EDGE-ON-HUDSON

APPLICATION FOR SITE PLAN & SUBDIVISION APPROVAL

PHASE ONE SUPPLEMENTAL SUBMISSION

Re: Phase 1 Site Plan and Subdivision Application
Edge-On-Hudson Riverfront Development
199 Beekman Avenue, Sleepy Hollow

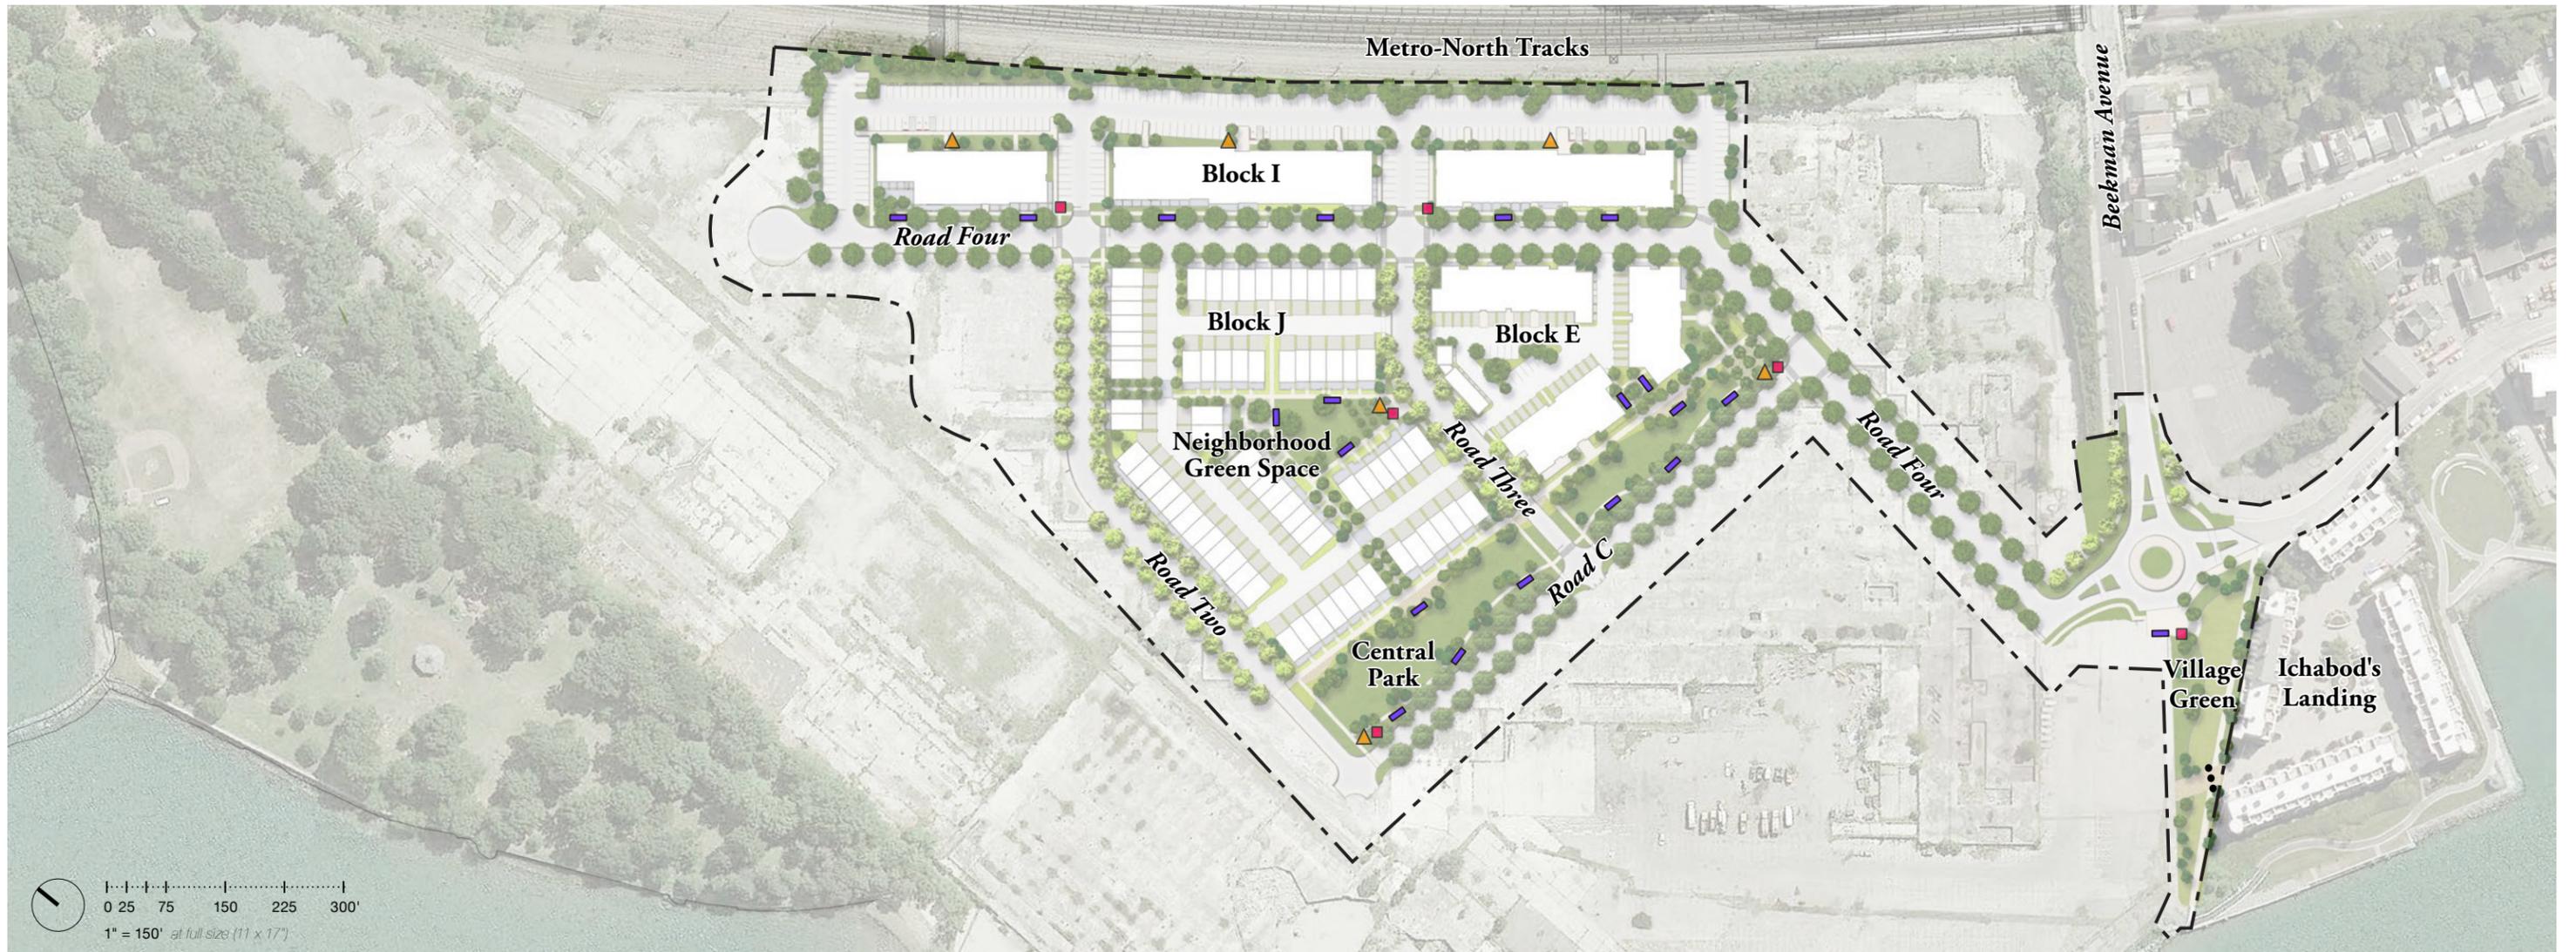
17. **Comment:** *As part of the submission documents related to the Central Park Design, there is a reference to an “outdoor room” and “market courtyard” but the details of these two concepts are not apparent. The “market courtyard” concept sounds like an open area, perhaps treated with decorative paving that could be used for multiple small-scale public functions like a farmers market. Located at the south end of Central Park, this is a key location with high visibility along Road Four and with an extended view down the Central Park expanse to the Hudson River. Similarly the “outdoor room” concept appears to imply a more formal space for the public to sit and gather. It would be helpful to have a better understanding of the treatments proposed regarding the use of pavers, wall treatments, lighting and street furniture.*

Response: The three block long Central Park connects to the waterfront via a meandering park path comprised of decomposed granite which is designed to be a welcoming open space for both the community and Village residents. The design palette celebrates the natural setting and heritage of the Hudson River. To add variety and create multiple spaces within the larger Central Park a “market courtyard” and “outdoor rooms” have been incorporated into the design. Both signify gathering spaces of different sizes and treatments. The market courtyard is intended to be a community gathering space created by decomposed granite within a tree bosque providing shade during the summer and spring months and providing seasonal interest throughout the year.

The outdoor rooms provide neighborhood seating areas with benches set within decomposed granite and surrounded by plantings. The open lawn area provides a casual community gathering spaces for picnics and passive recreation. Twelve foot tall pedestrian lighting, model Kastrup, manufactured by Louis Poulsen (or equivalent), is proposed along the northeastern portion of the Central Park adjacent to the townhomes and Block E housing. Along Road C and Road Three, fourteen foot tall street fixture lighting is proposed in the same model Kastrup (or equivalent). Benches and refuse containers are proposed in appropriate public and open space areas throughout the

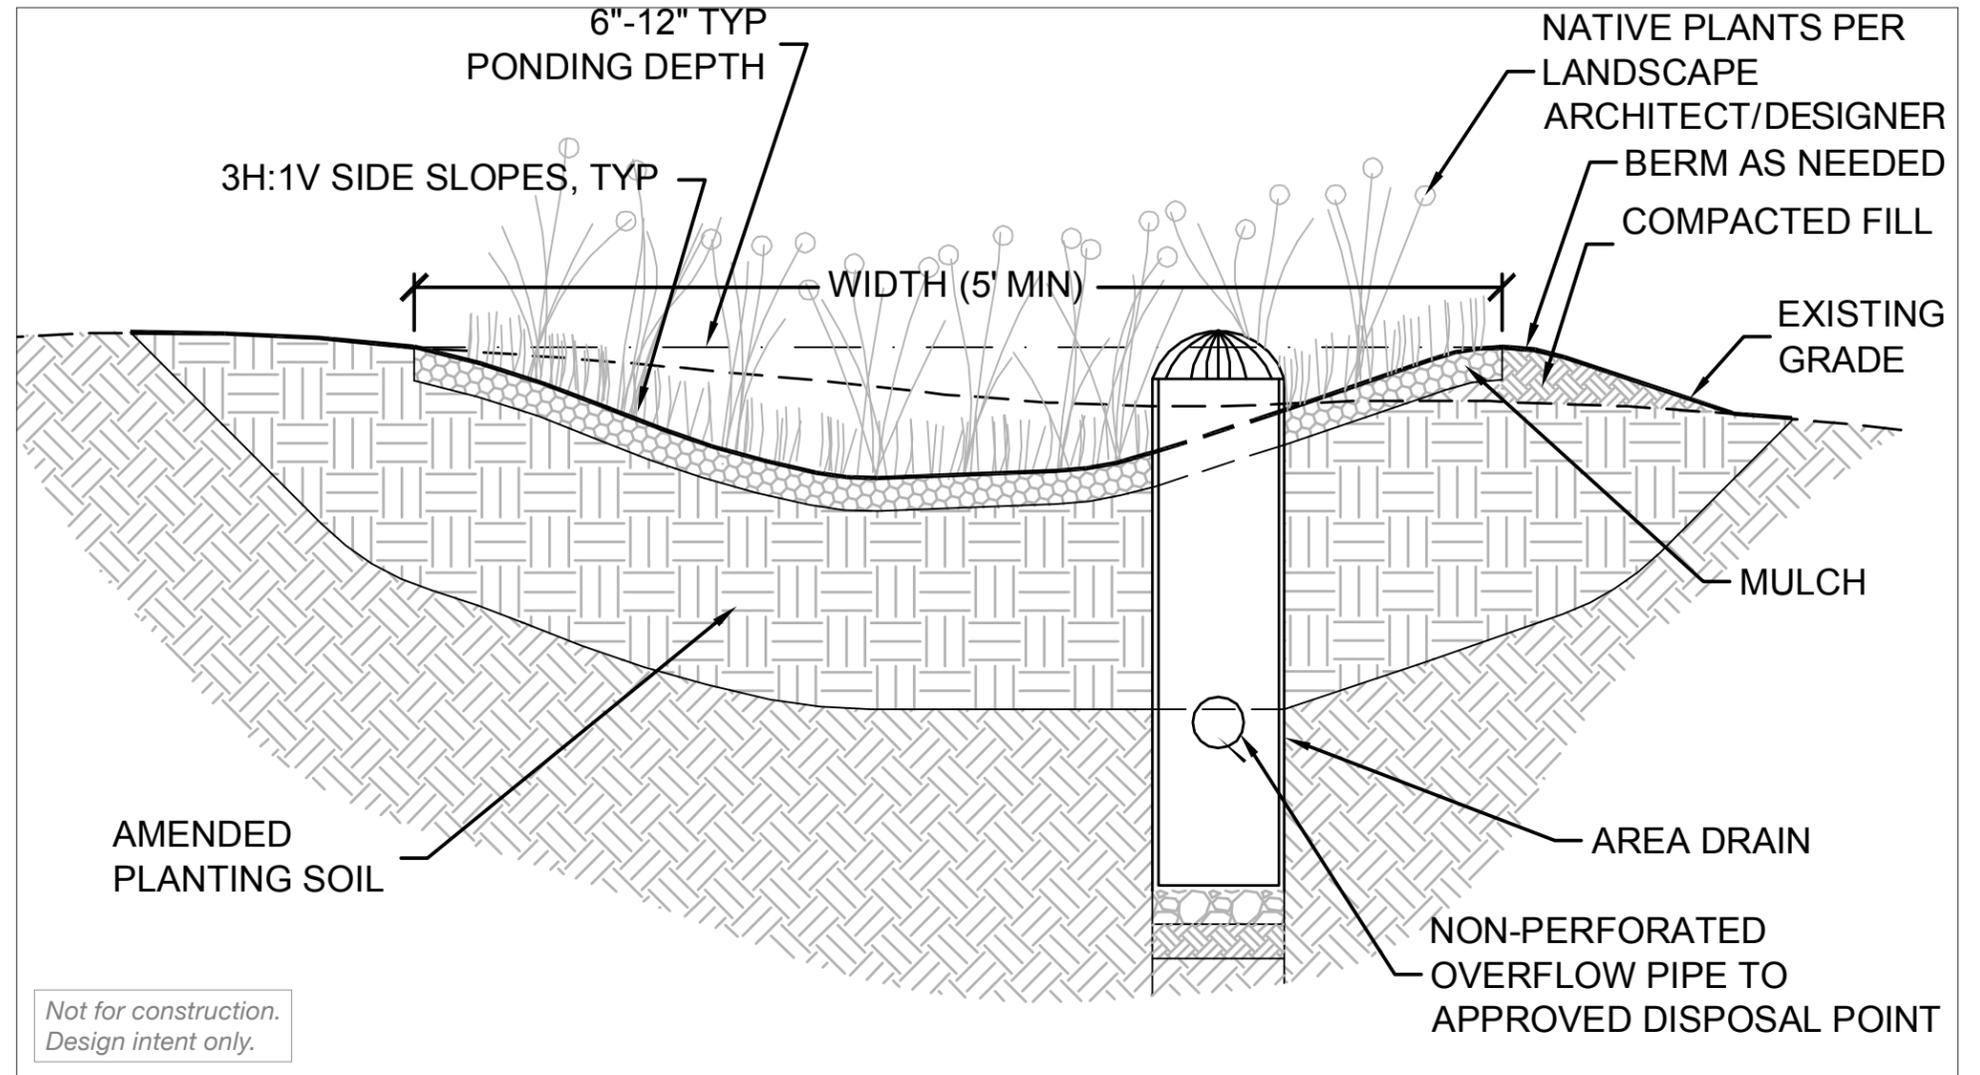
6. **Comment:** *While the environmental review and subsequent Environmental Findings (June 7, 2011 p. 8; July 24, 2007 Environmental Findings p. 27 and 39) note that the project will result in a substantial reduction in the total amount of impervious coverage, there is still a requirement to include a series of structural measures which will provide sediment and nutrient removal. During the intervening years from the 2007 Environmental Findings to the time of subject Site Plan submission there have been significant improvements in stormwater management techniques relative to “green streets” practices. It wasn’t apparent that the Applicant had provided the additional detail as to the proposed water quality treatments being incorporated into the Site Plan design and potential application of “green streets” techniques. If the Applicant is not proposing to use these techniques, it would be helpful to understand why they could not be incorporated.*

In terms of “green streets” practices, the Applicant is now proposing to provide localized bio-retention areas or rain gardens (see page 6 of Landscape Architectural Exhibit) to provide supplemental water quality treatment within the interior areas of the Phase 1 plan.

- Surface runoff is directed into shallow, landscaped depressions that provide on-site treatment of stormwater runoff.
- Rain gardens allow runoff to percolate through the soil bed and return to the stormwater system.
- Using a combination of native trees, shrubs, and herbaceous material is critical to the function and aesthetic value of the rain garden.

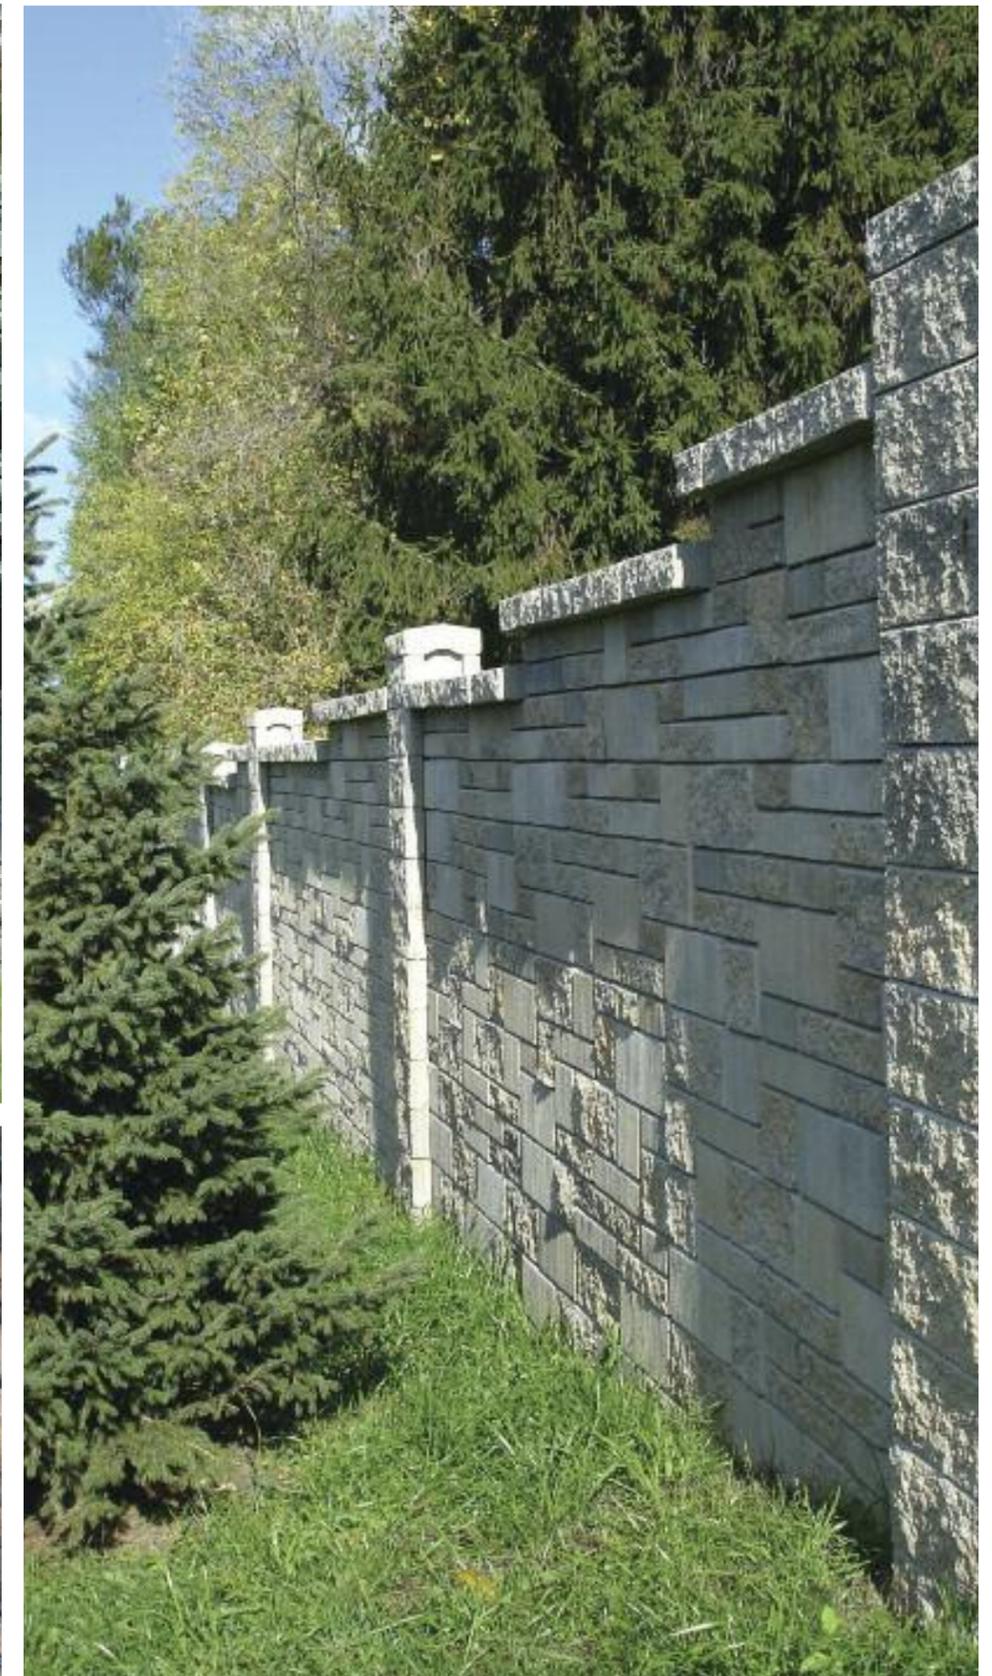
19. **Comment:** *The Applicant should provide a detail of the Phase I perimeter fencing.*

Response: A detail of the temporary Phase I perimeter fencing is shown on Sheet SP-8.3. Also provided and attached hereto as pages 7 and 8 of the Landscape Architecture Exhibit is a detail of the privacy wall proposed along the Metro-North right-of-way in the northeastern portion of the site, east of the I buildings.

The privacy wall screens the Metro North Railroad Right-of-Way with a 6' height wall constructed to visually match the materials of the bridges across the Hudson River Valley.
